**ARROWSMITH NORTH SILICA SAND PROJECT (EPBC Act Referral 2020/8788) -
Section 156A Request**

VRX Silica Limited (VRX) is seeking approval to develop the Arrowsmith North Silica Sand Project (the Proposed Action) located in the Mid-West region of Western Australia (WA), approximately 270 kilometres (km) north of Perth. The Proposal will involve extraction of silica sand from the top of a dune to produce high-grade silica sand product via mechanical upgrading.

The Proposed Action has evolved since the original referral under the EPBC Act and a number of minor elements have changed as a result. The purpose of this letter is to request a variation to the referred Proposed Action under Section 156A of the EPBC Act. This request for variation has been prepared according to section 5.07 - 5.09 of the Environment Protection and Biodiversity Conservation Regulations 2000 (EPBC Regulations) and accordingly provides the following information:

Figure 1: Development Envelope and Disturbance Footprint of the original Proposed Action

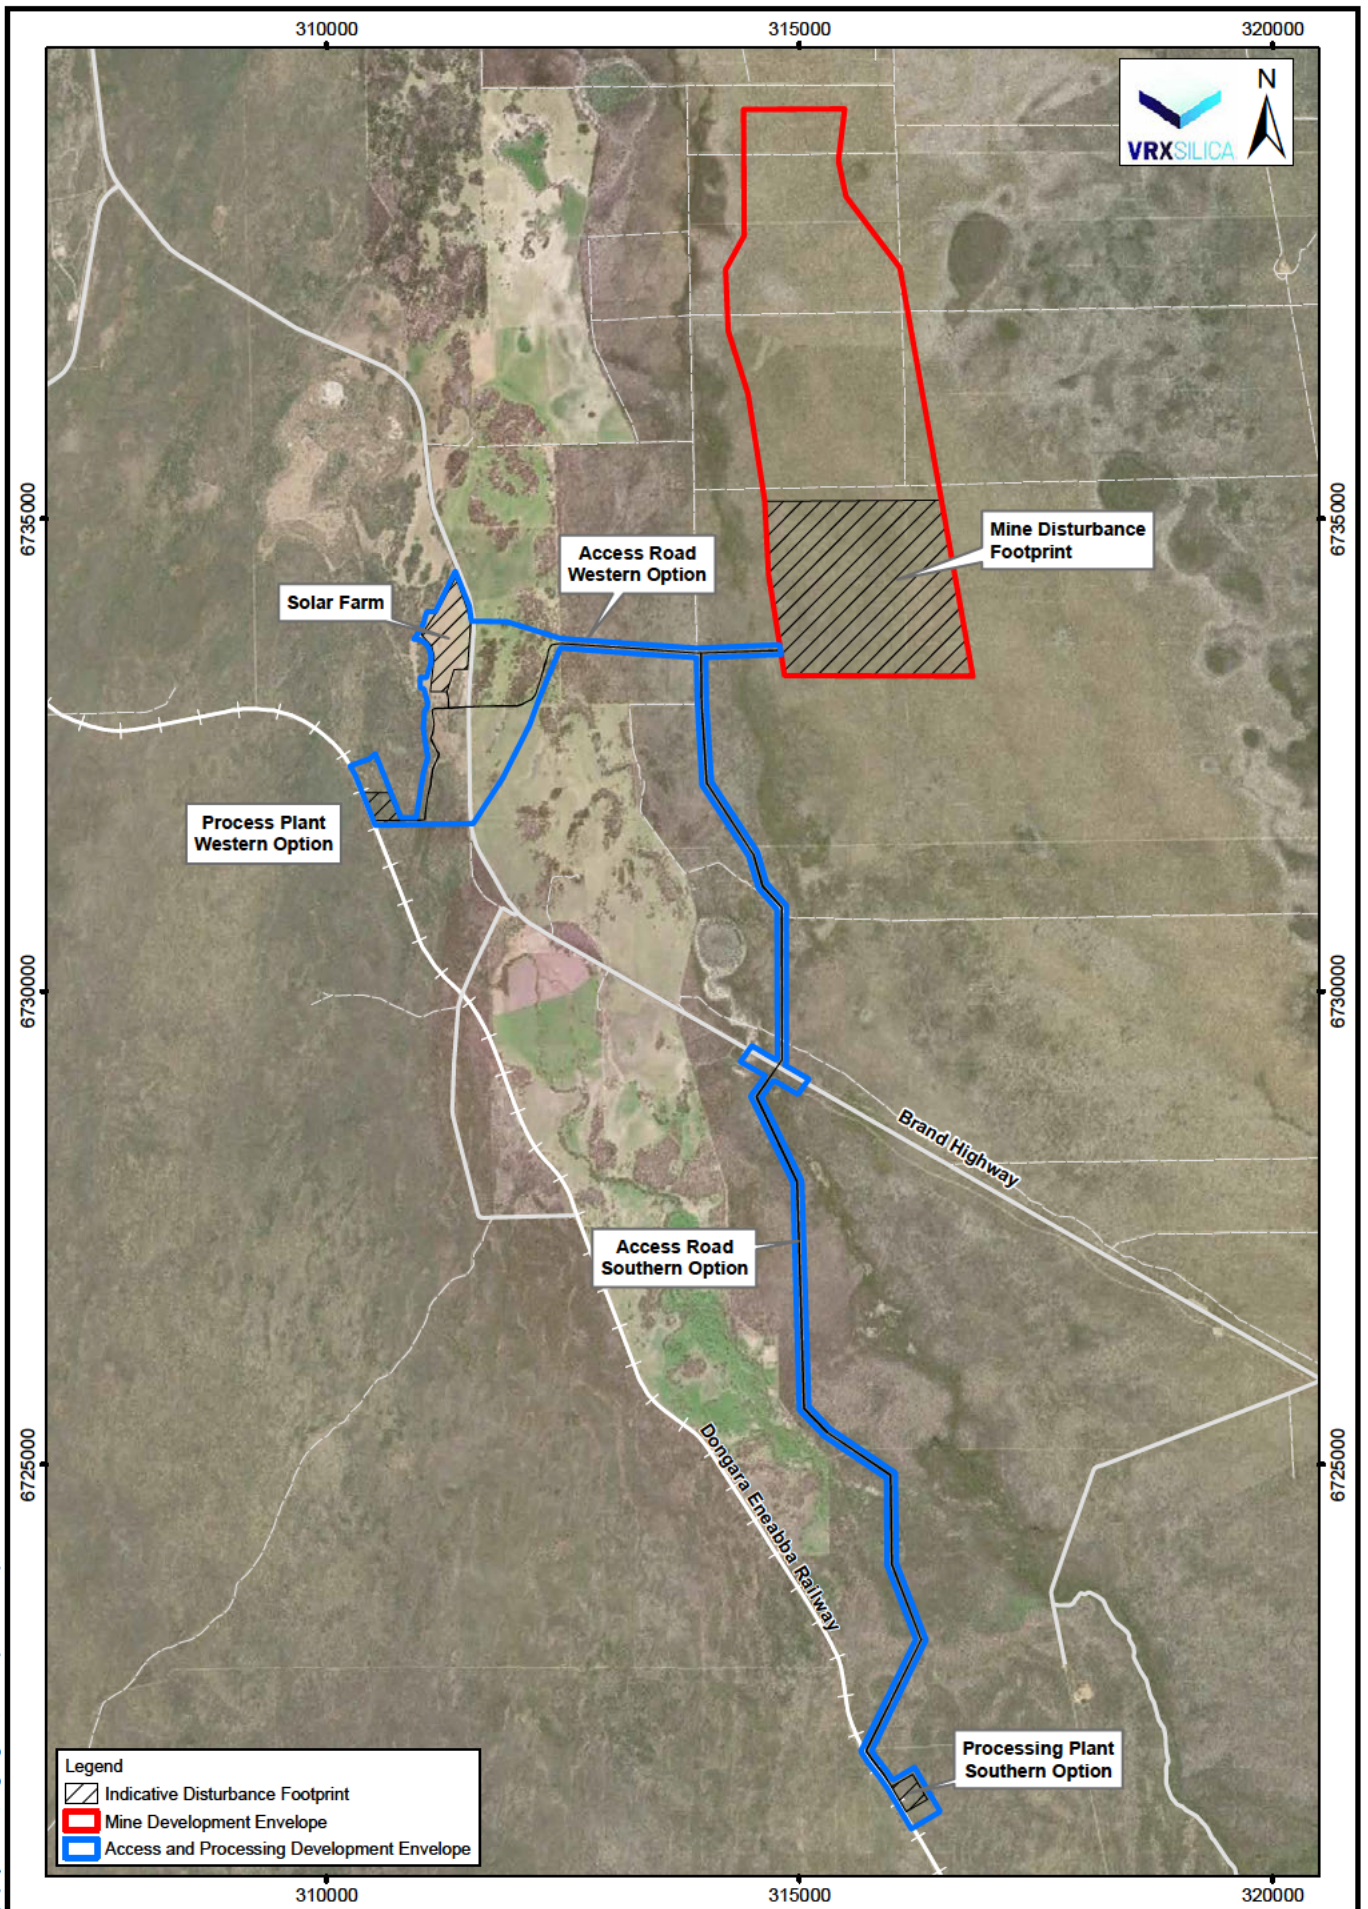
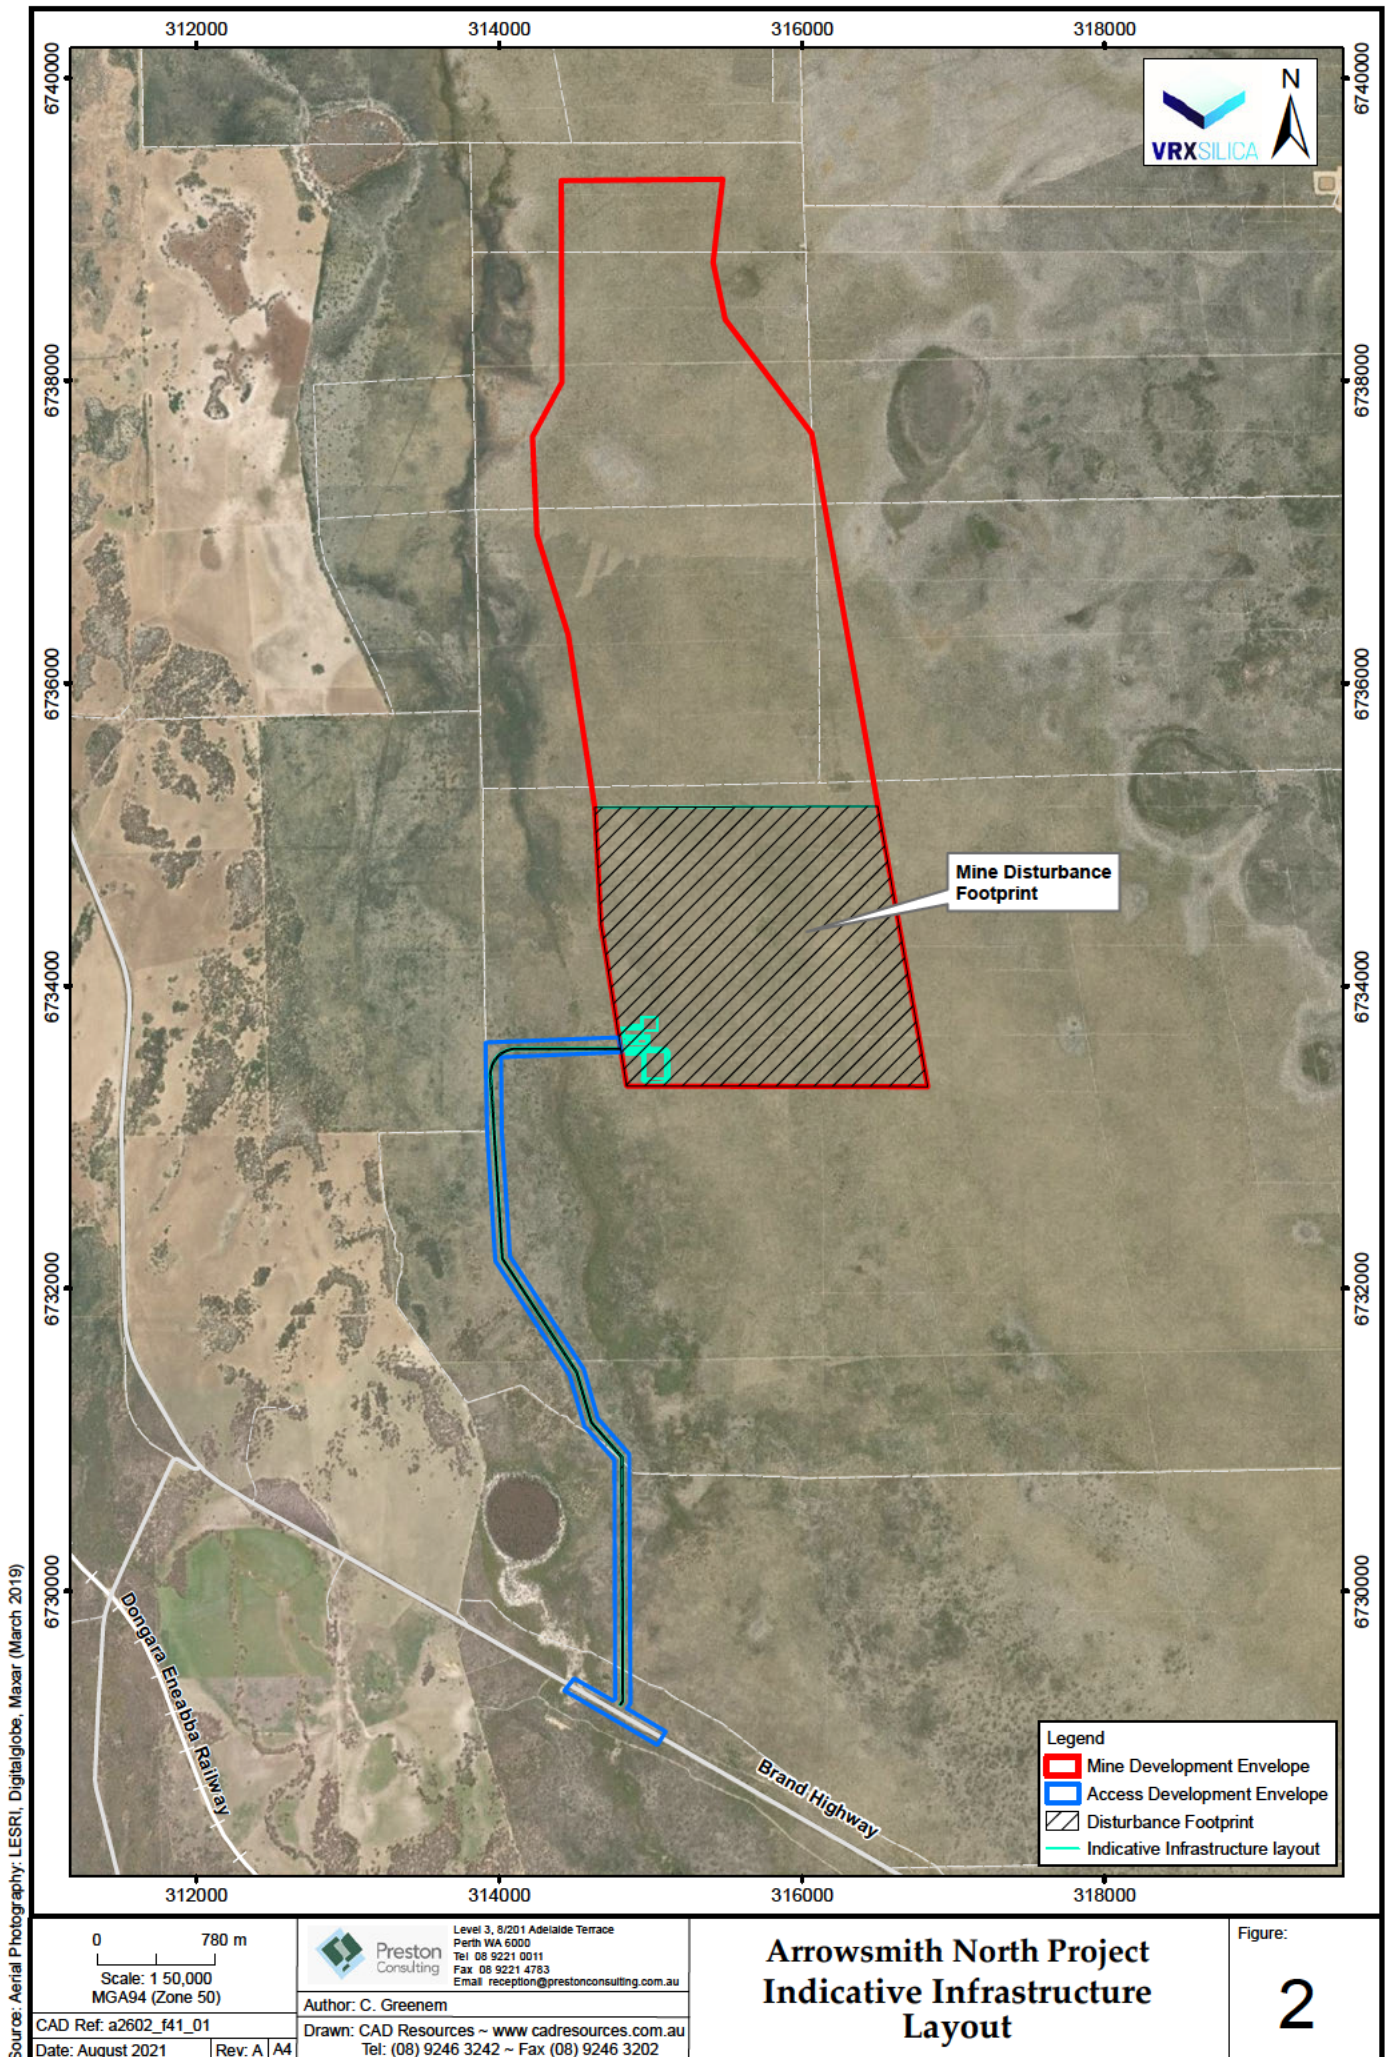
1. Relocation of the silica sand processing plant to within the Mine Development Envelope;
2. A reduction in the extent of the Access and Processing Development Envelope from 447 ha to 61 ha (a reduction of 386 ha);
3. A reduction in the extent of clearing from 412.2 ha to 366.5 ha (a reduction of 45.7 ha) as a result of:
 - a. Relocating the processing plant footprint to within the mining footprint;
 - b. Removal of the western access route and shortening the extent of the southern access route;
 - c. Removal of a solar farm; and
 - d. Removal of the train loadout facilities.

Table 1 provides further detail of the proposed changes to the Proposed Action. The Development Envelope and Disturbance Footprint of the original Proposed Action is provided in Figure 1 and the Development Envelope and Disturbance Footprint of the Proposed Variation is shown in Figure 2.

VRX has chosen to transport ore to Geraldton Port via road instead of rail as defined in the original Proposal. As a result, VRX proposes to use only the Southern access option to the extent of the intersection with the Brand Highway. As a result, the Access and Processing Development Envelope (proposed to be re-named as the Access Development Envelope) has been reduced from 447 ha to 61 ha and the extent of clearing within this Development Envelope has been reduced from 52.2 ha to 6.5 ha. The Western option of the Access and Processing Development Envelope is no longer required and has been removed from the Development Envelope boundary (Figure 1). The revisions were due to several reasons:

Figure 2: Development Envelope and Disturbance Footprint of the variation to the Proposed Action
